ENGINEERING CHANGE PROPOSAL (ECP), PAGE 1

c. SYSTEM DESIGNATION: M260 & M261 ROCKET LAUNCHER

d. ECP NO.: MI-M7565

13. TITLE OF CHANGE: ELIMINATION OF UNNESSECCARY HOLE, CONNECTOR MODIFICATION AND COMBINATION OF TWO PARTS

9. TITLE OF DOCUMENT
LAUNCHER, ROCKET, AIRCRAFT: 2.75 INCH, 7-TUBE, M260

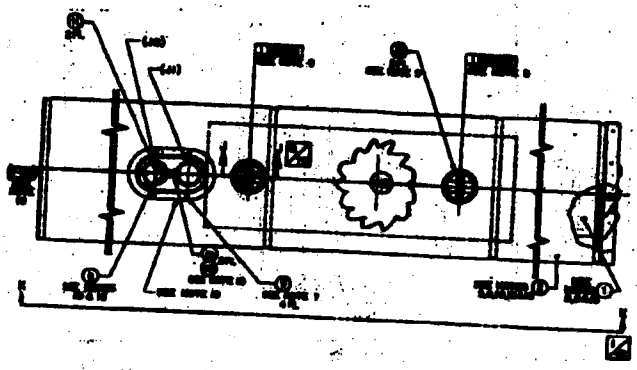
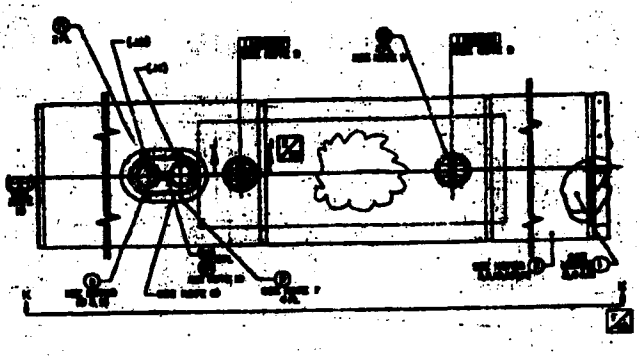
13. DESCRIPTION OF REVISION
THE DRAWING HAS BEEN REVISED AND REDRAWN. THE CLOUDS DEPICT THE AREAS OF CHANGE.

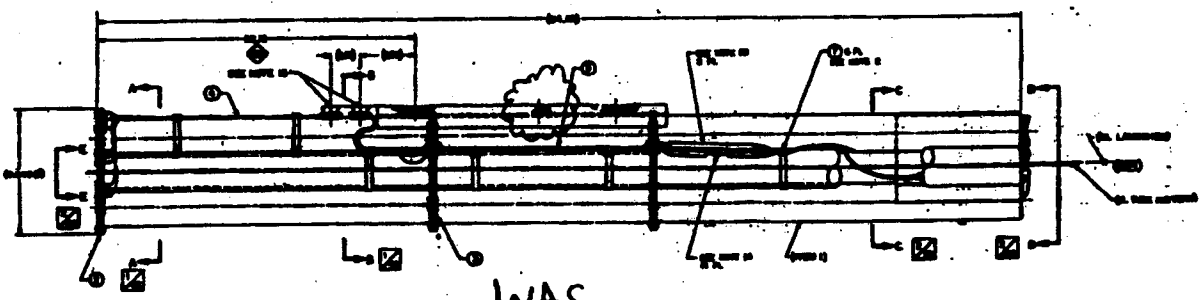
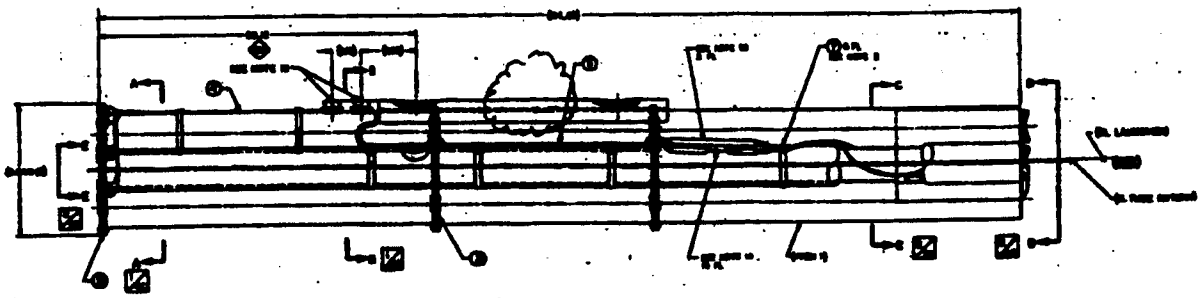
13. DESCRIPTION OF REVISION
THE DRAWING HAS BEEN REVISED AND REDRAWN. THE CLOUDS DEPICT THE AREAS OF CHANGE.

ECP NO. MI-M7565 NOR 3/18 SHEET 2 OF 3

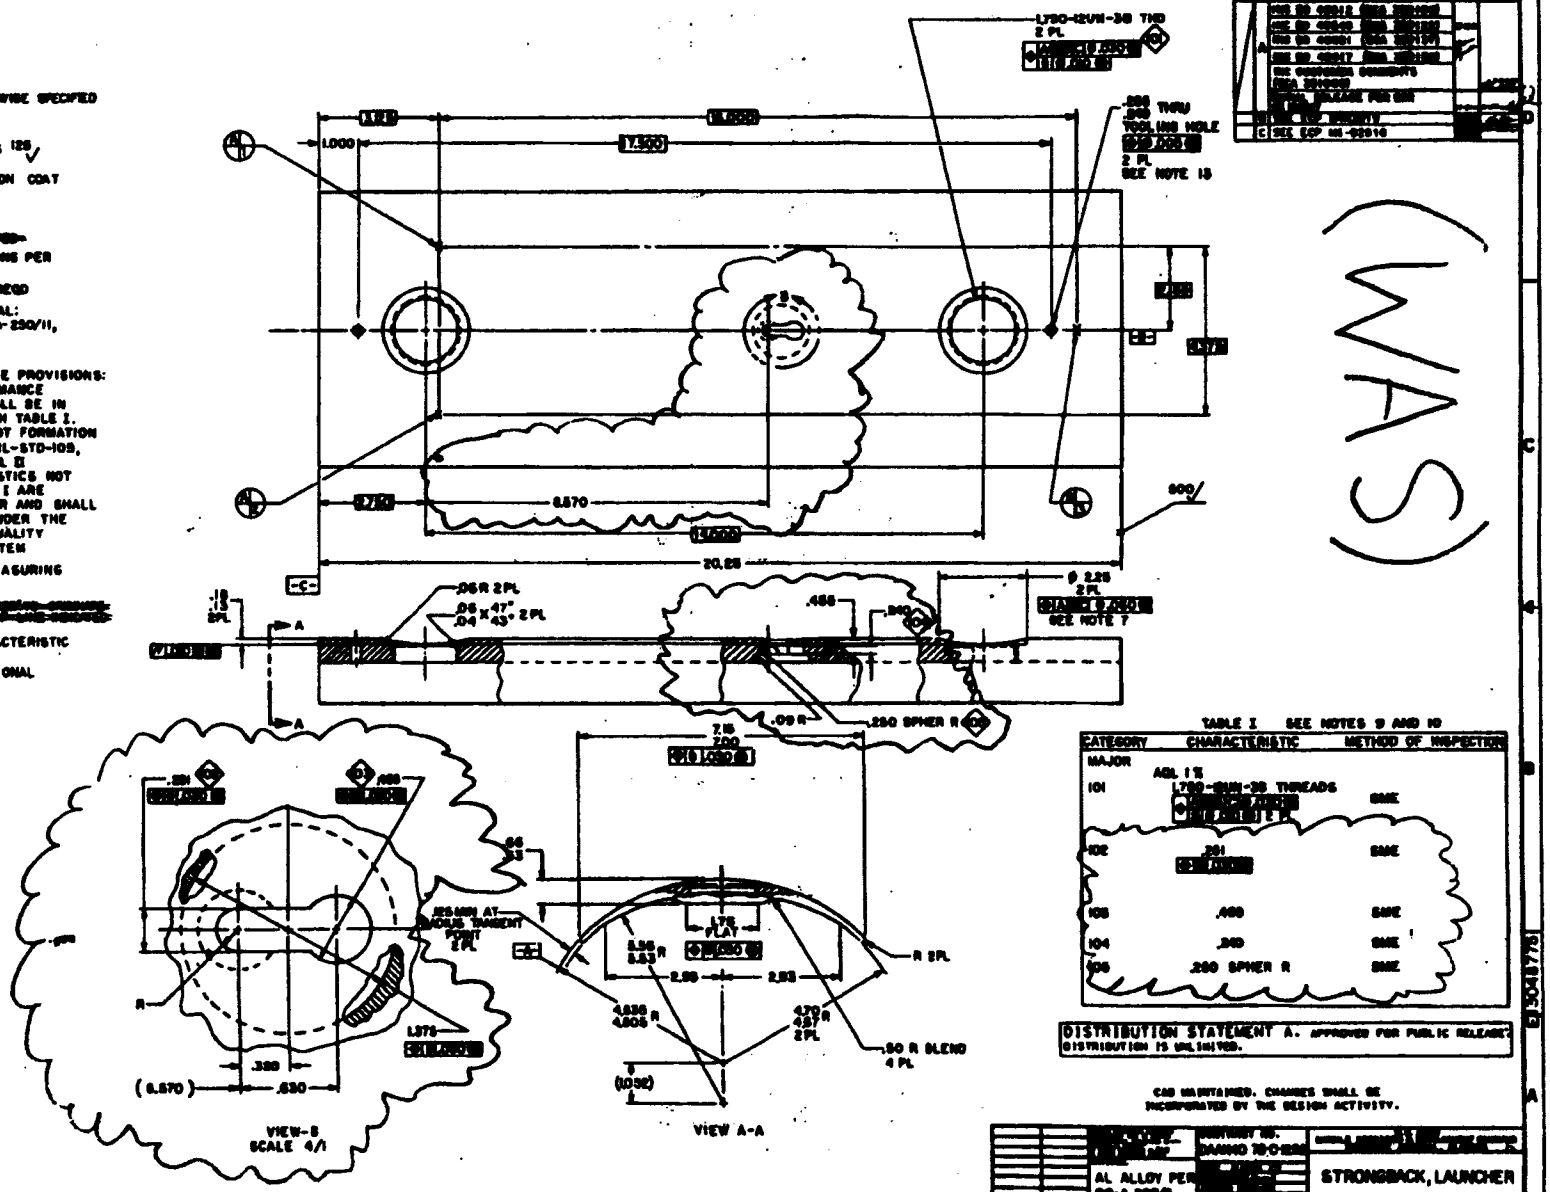
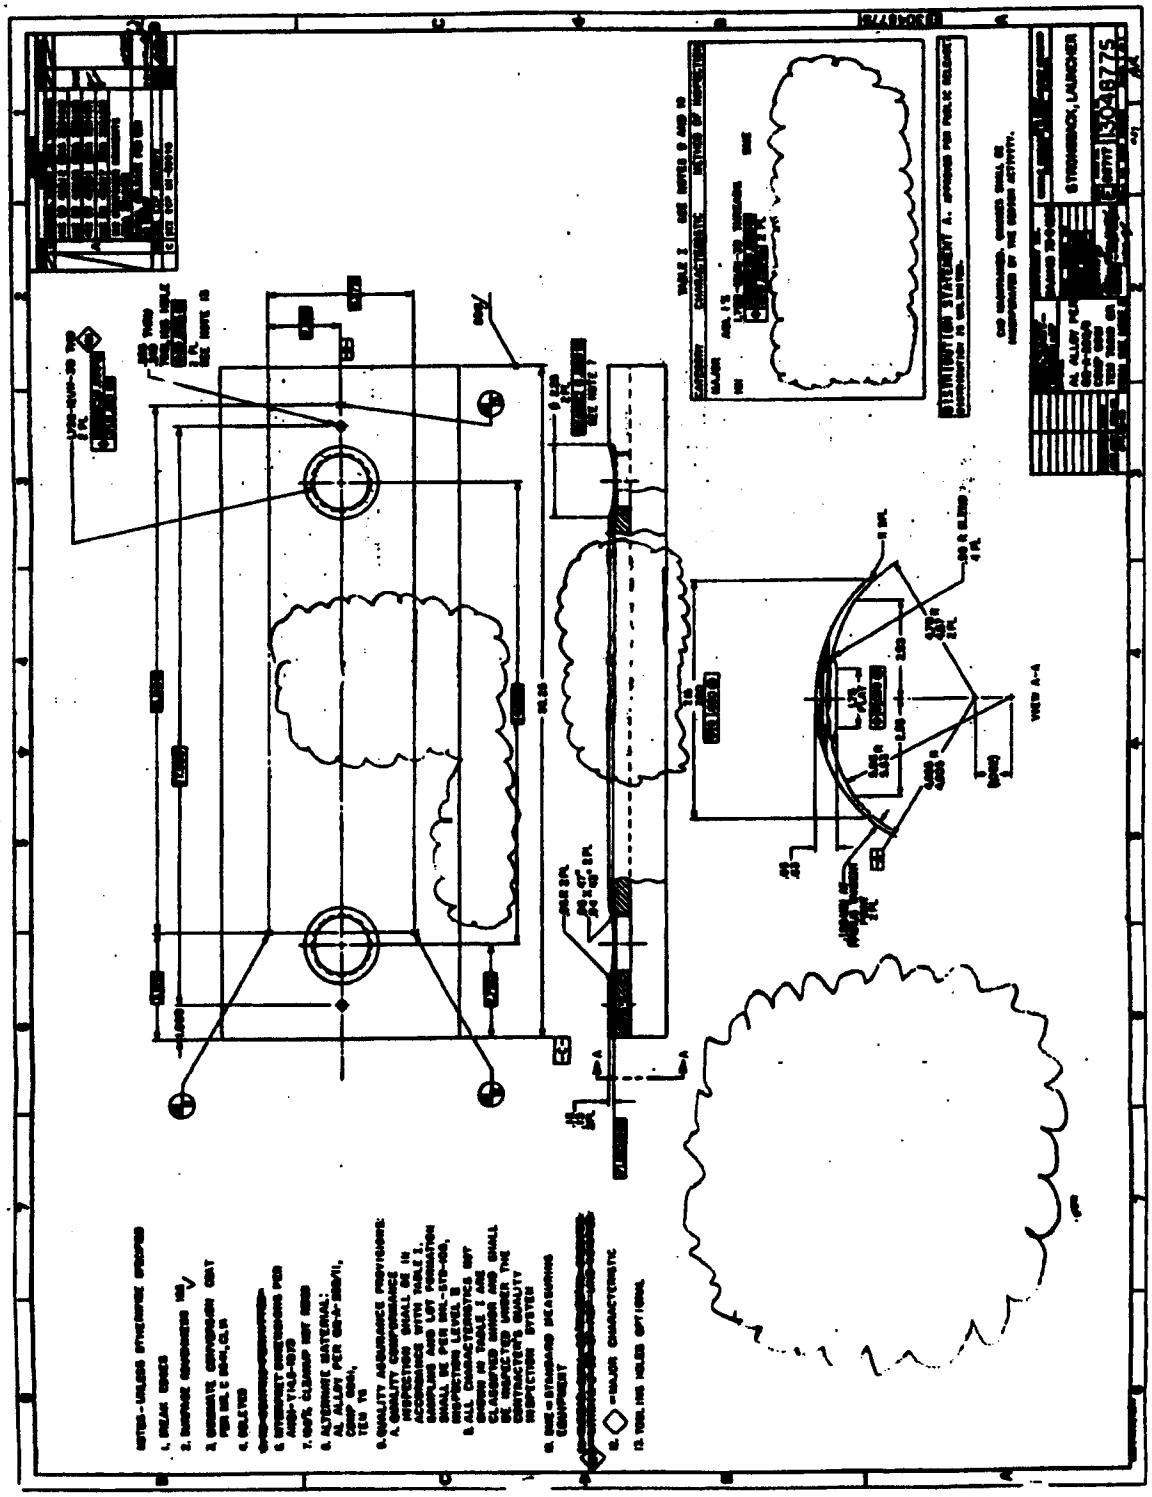
THE DRAWING HAS BEEN REVISED AND REDRAWN ON SHEETS 2 THRU 3. THE CLOUDS DEPICT THE AREAS OF CHANGE.

9. TITLE OF DOCUMENT	10. REVISION LETTER		11. ECP NO.
	a. CURRENT	b. NEW	
SKIN, LAUNCHER	F	G	MI-M7565

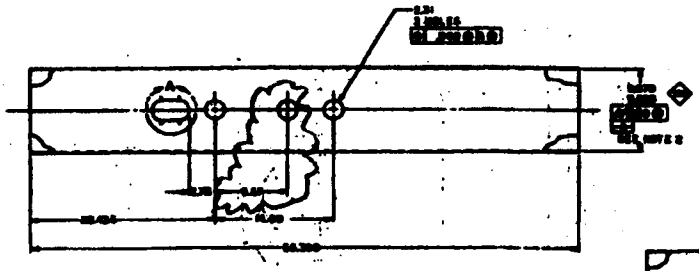
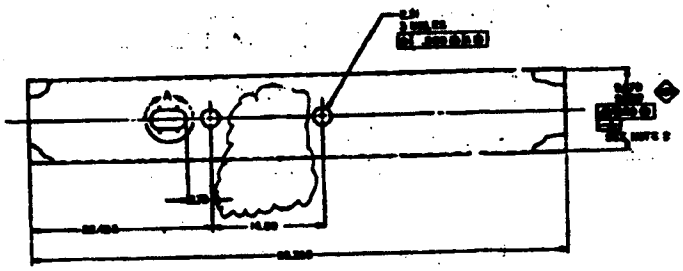
THE DRAWING HAS BEEN REVISED AND REDRAWN. THE CLOUDS DEPICT THE AREAS OF CHANGE.

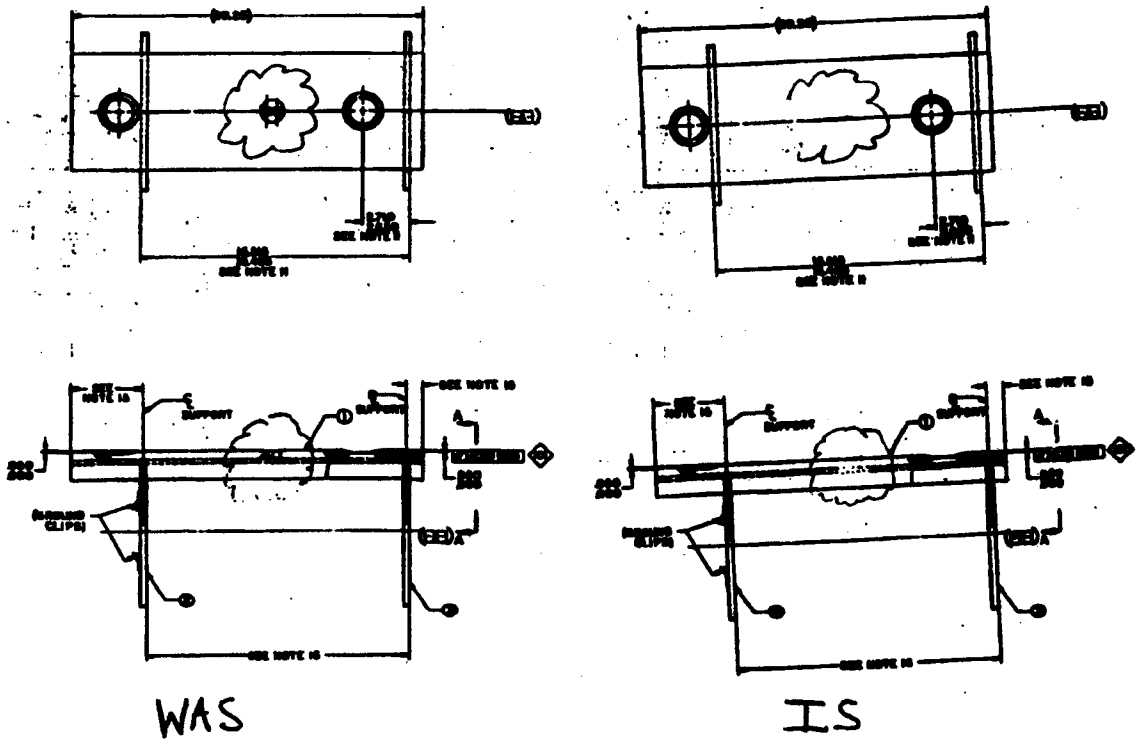
13. DESCRIPTION OF REVISION
THE DRAWING HAS BEEN REVISED AND REDRAWN. THE CLOUDS DEPICT THE AREAS OF CHANGE.

9. TITLE OF DOCUMENT: DETENT ASSEMBLY

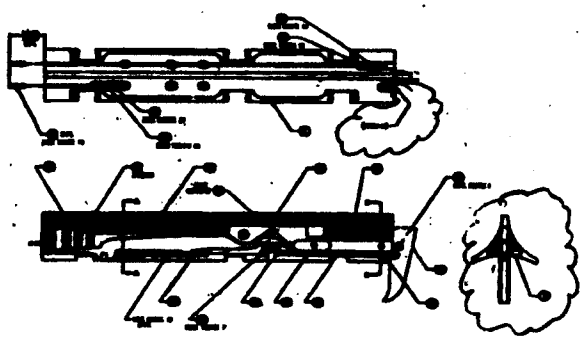
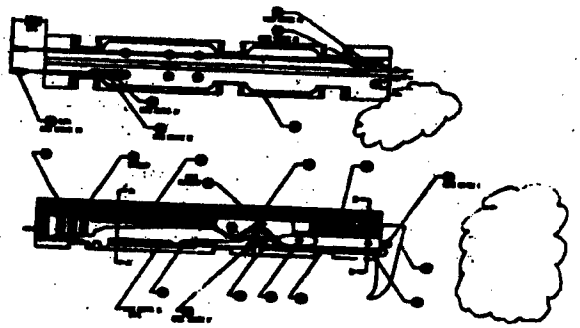
13. DESCRIPTION OF REVISION
THE DRAWING HAS BEEN REVISED AND REDRAWN. THE CLOUDS DEPICT THE AREAS OF CHANGE.

DRAWING 13048801, SHT 1, SEC 3B

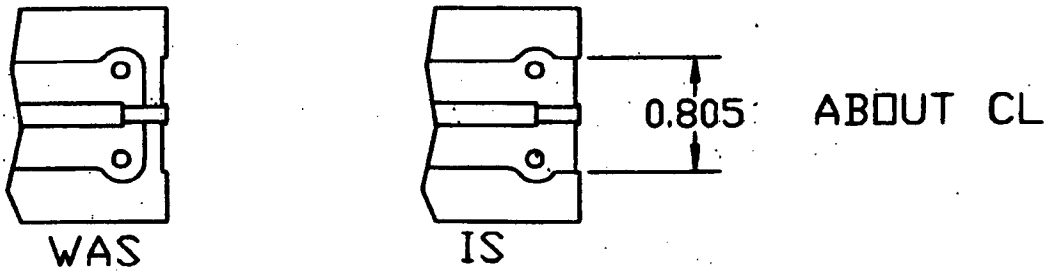
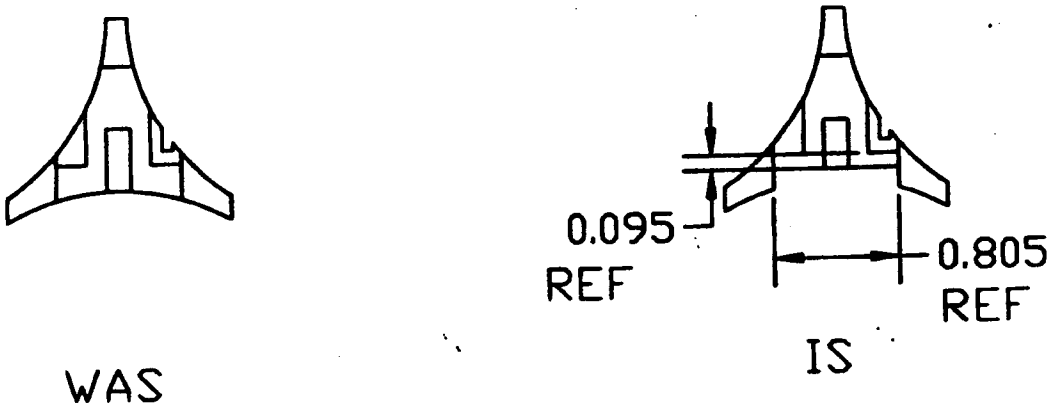
13. DESCRIPTION OF REVISION
THE DRAWING HAS BE REVISED AND REDRAWN ON SHEETS 1 THRU 2. THE CLOUDS DEPICT THE AREAS OF CHANGE.

8. MATERIAL THERMOPLASTIC POLYESTER PER MIL-M-24519 TYPE GPT-3CF, COLOR BLACK PER FED-STD-595.
ALTERNATE MATERIAL: THERMOPLASTIC POLYESTER PER MIL-P-46161, GR B, CL 3. COLOR BLACK PER FED-STD-595

8. MATERIAL THERMOPLASTIC POLYESTER PER MIL-M-24519 TYPE GPT-3CF, COLOR BLACK PER FED-STD-595.
~~ALTERNATE MATERIAL: THERMOPLASTIC POLYESTER PER MIL-P-46161, GR B, CL 3. COLOR BLACK PER FED-STD-595.~~

ECP NO. MI-M7565 NOR 10/18 SHEET 2 OF 2

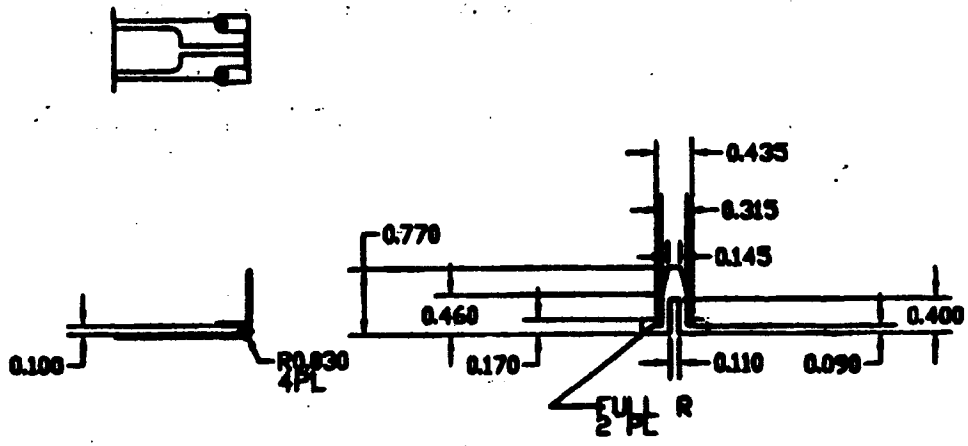
THE DRAWING HAS BEEN REVISED AND REDRAWN ON SHEET 2. THE CLOUDS DEPICT THE AREAS OF CHANGE.

SHEET STEEL, CORROSION RESISTANT (17-7) IN ACCORDANCE WITH MIL-S-25043, CONDITION A, HEAT TREATED TO RH 950 CONDITION FROM DRAWING NO. 958AS169

9. TITLE OF DOCUMENT	10. REVISION LETTER		11. ECP NO.
	a. CURRENT	b. NEW	
SKIN, LAUNCHER	C	D	MI-M7565

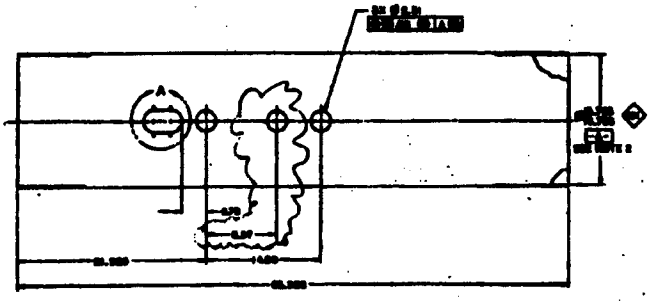
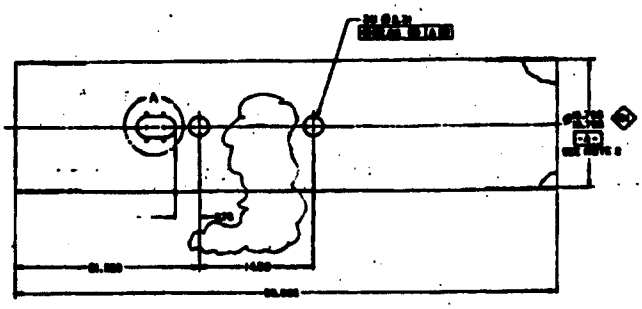
THE DRAWING HAS BEEN REVISED AND REDRAWN. THE CLOUDS DEPICT THE AREAS OF CHANGE.

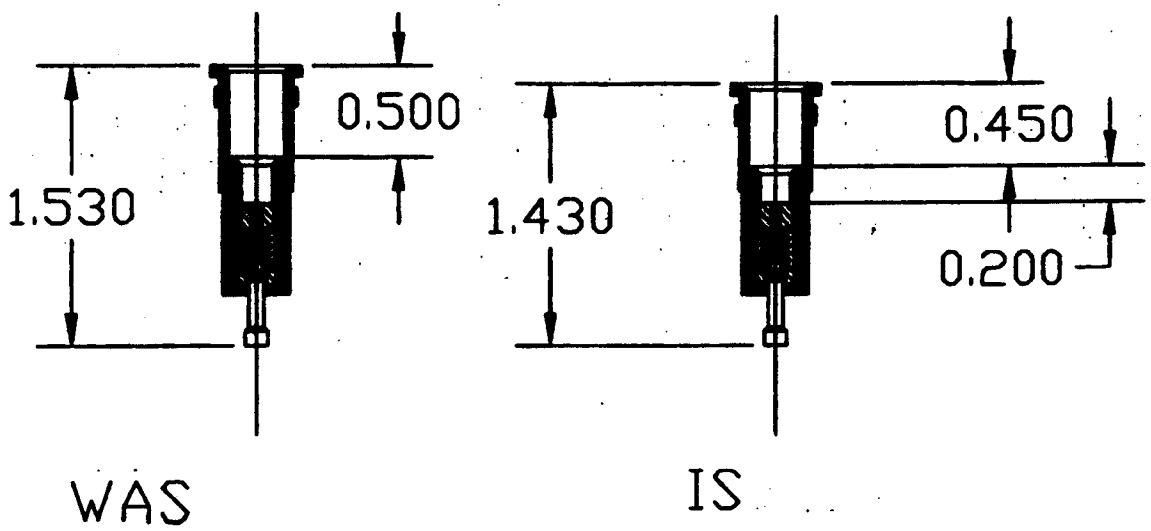
13. DESCRIPTION OF REVISION
THE DRAWING HAS BEEN REVISED AND REDRAWN. THE CLOUDS DEPICT THE AREAS OF CHANGE.
